ADDENDUM NO. 1

MONTGOMERY COUNTY SWCD NEW STORAGE BUILDING

MAY 13, 2025

Re: Montgomery County Soil & Water Conservation District

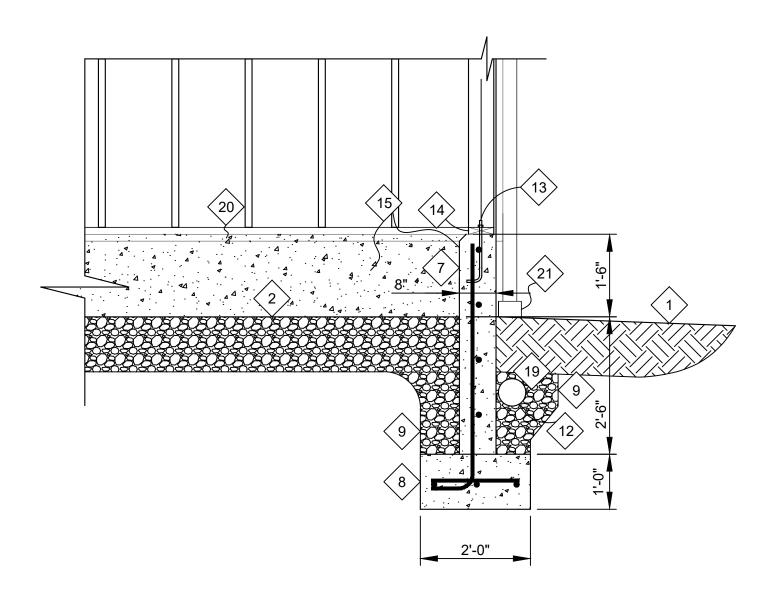
- 2. A 5/8" OSB sheathing shall be required to cover the roof purlins prior to adding the roof underlayment and steel roofing material.
- 3. The bed rock in the area has been determined to be between 30" to 48" below grade. Based on the bed rock depth and the desire to keep costs as economical as possible while maintaining structural integrity, the following adjustments will be made to the footer and stem wall construction.
 - a. The stem wall height above grade has been adjusted from the 24" shown on the plans to 18". The wall height below grade has been adjusted to be 30" below grade.
 - b. The footer depth can be shallower, and the wall heigh below grade can be less than the dimension noted on the revised footer/stem wall detail seen below as long as the footer is bearing on a solid section of bedrock.
